## **Invitation for Bid No. 2025-030**

### **Detention Center Sewer Screening**

#### **ADDENDUM No. 1**

**ISSUE DATE: March 26, 2025**

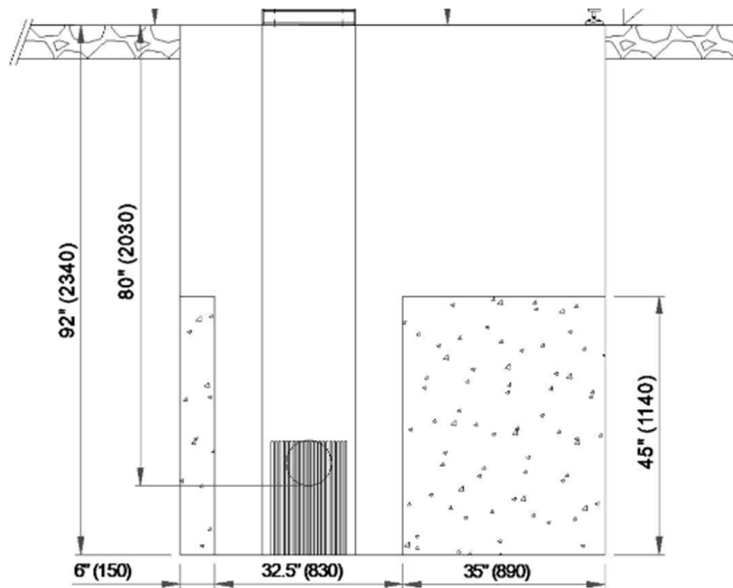
14. (P200) Please provide the dimensions for the detail view of the "Sewer Screen Equipment – Basis of Design."

Answer:
